**RE:** Petitioner #1544 -- LSE Pyxis LLC ("Lodestar") for a Declaratory Ruling that No Certificate of Environmental Compatibility and Public Need is Required for the Construction, Operation and Maintenance of Solar Photovoltaic Facility in Norfolk, Connecticut

PETITION NO. 1544

**PETITIONER LSE PYXIS LLC'S RESPONSES TO SITING COUNCIL  
INTERROGATORIES SET ONE DATED DECEMBER 2, 2022**

**Array 2 Site Plan**

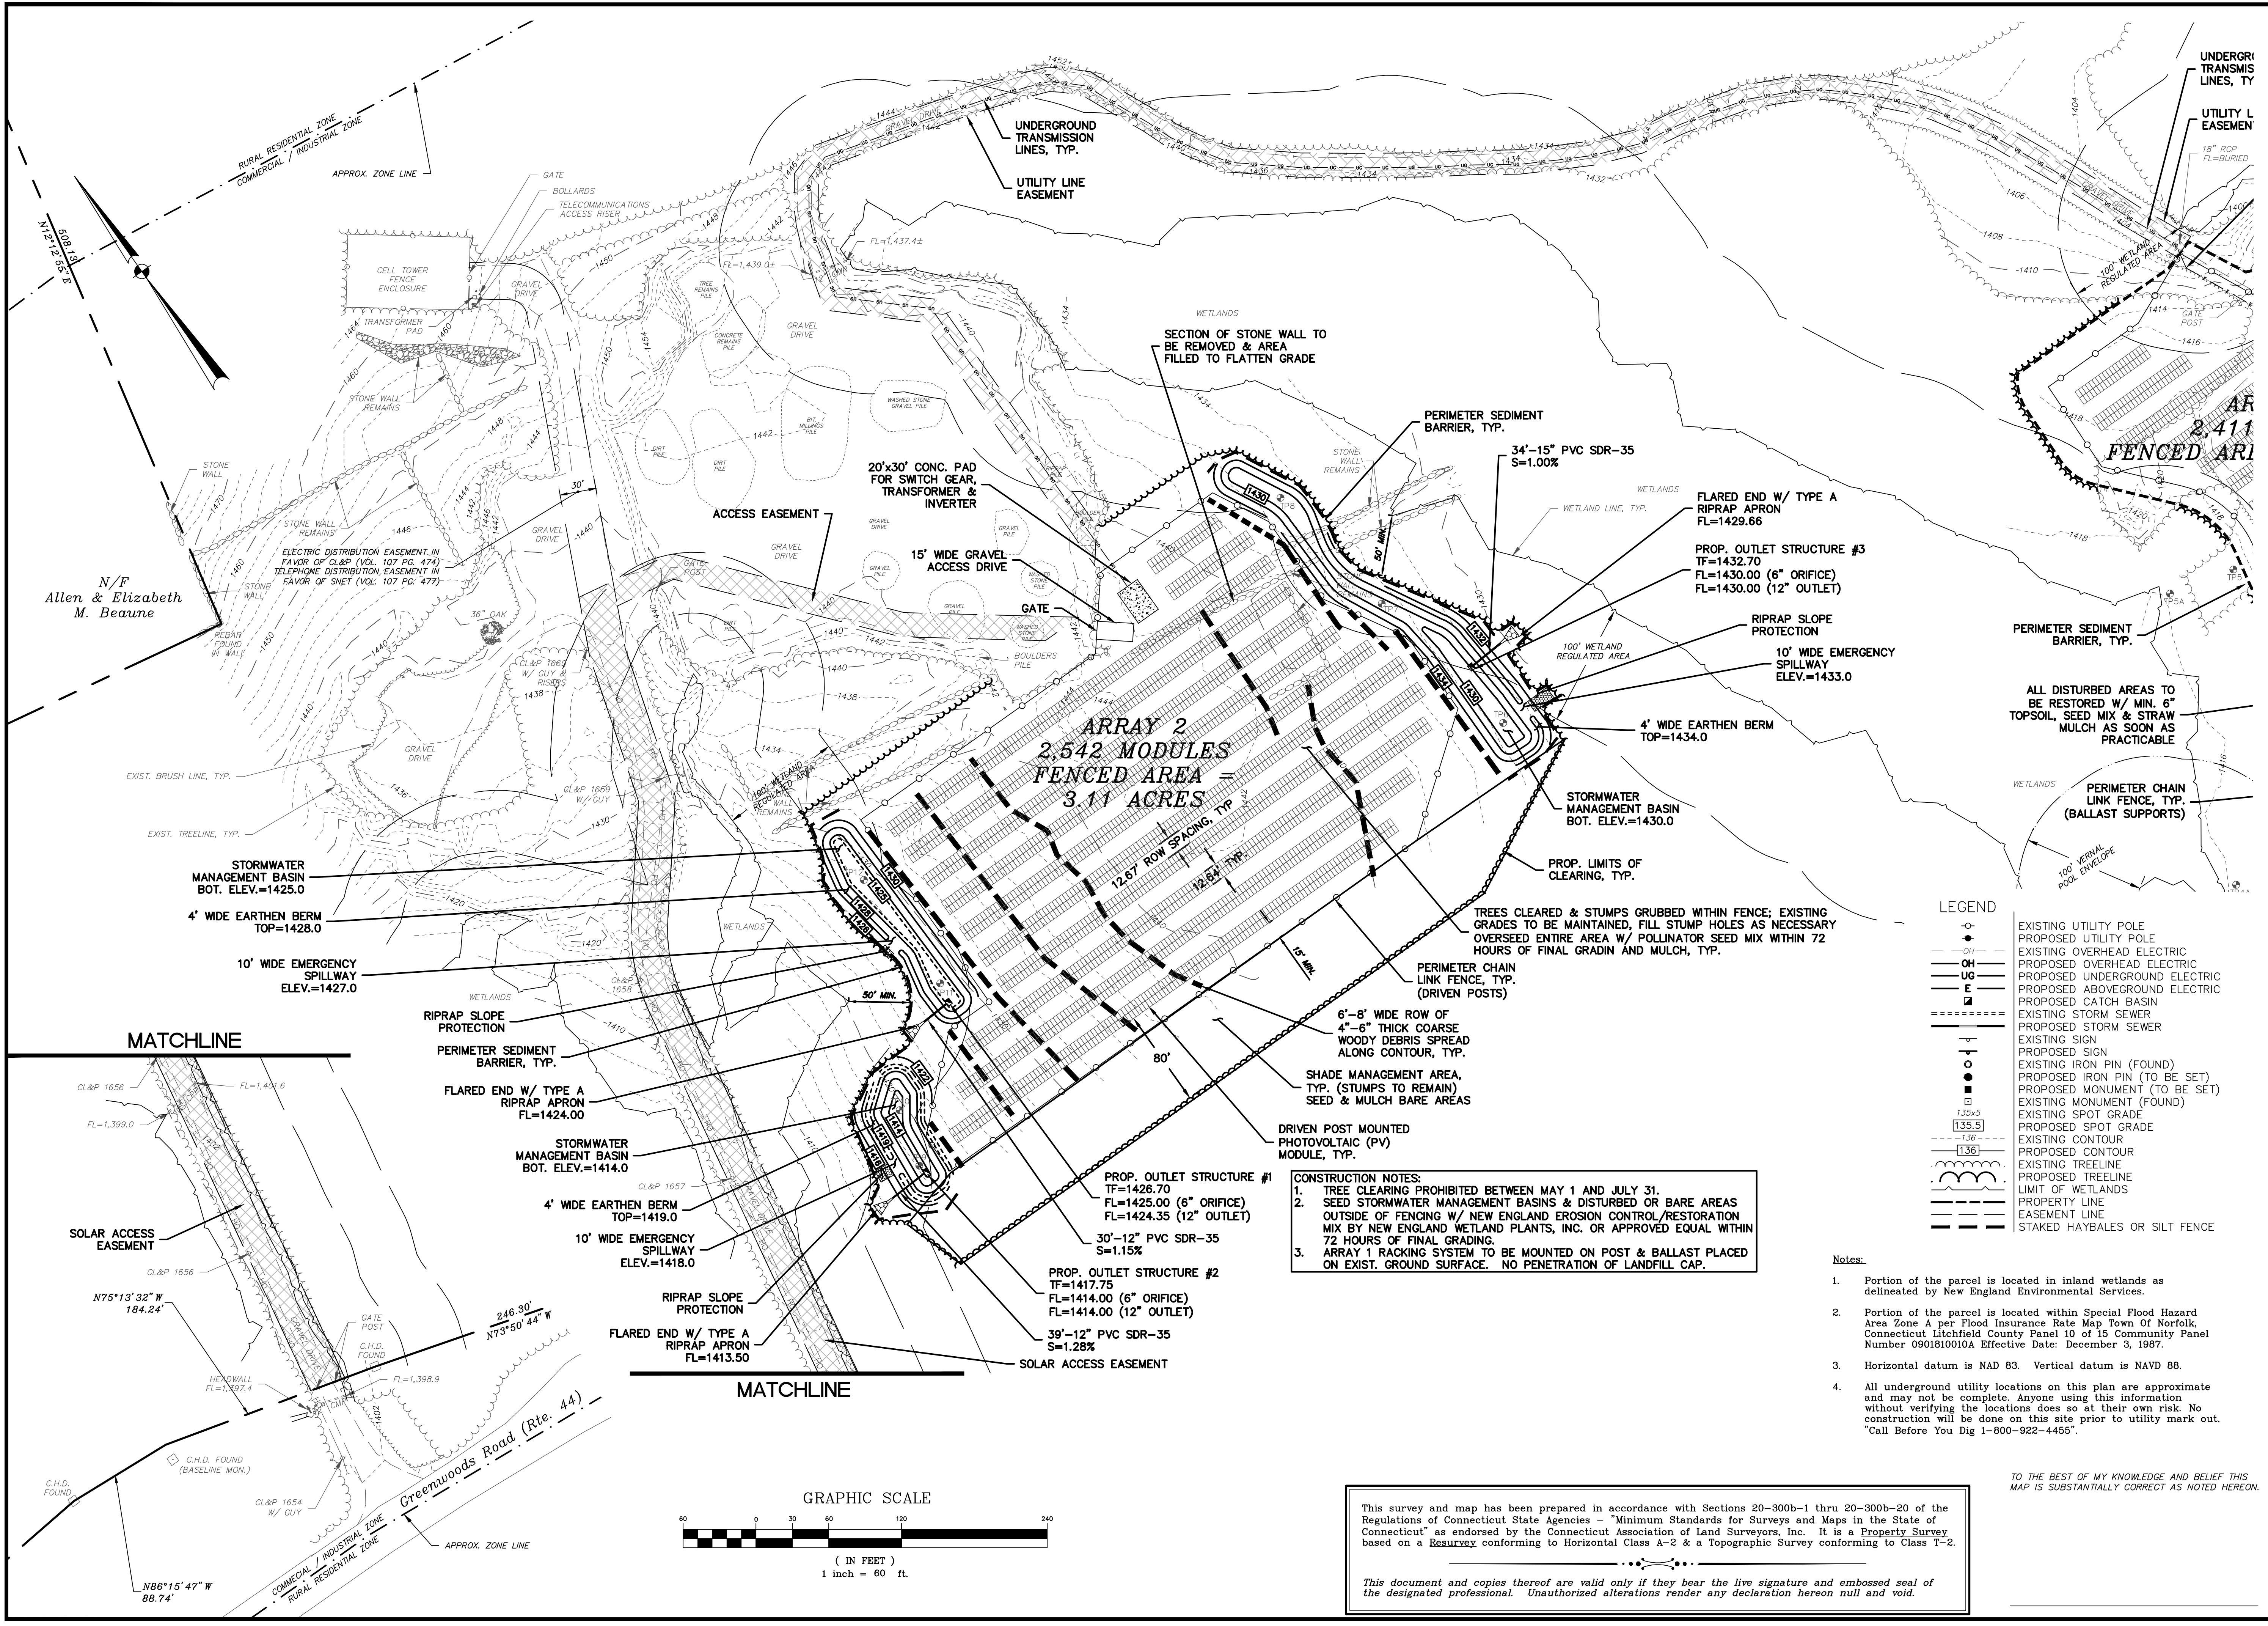
28. ***Referring to Array 2 Site Plan, the stormwater basin outfalls #1 and # 2 are within 50 feet to the adjacent wetland. Does a distance of less than 50 feet comply with DEEP's General Permit Appendix I? Explain. Can the outfalls and related construction limit of disturbance be relocated to provide a minimum 50-foot wetland buffer?***

RESPONSE: The revised site plans attached hereto as Exhibit 3 have been modified to move the discharge pipes from basin outfalls #1 and #2 so that they are now located outside of the 50-foot wetland buffer. Similarly, the construction limit of disturbance has been relocated such that the minimum 50-foot wetland buffer is maintained.
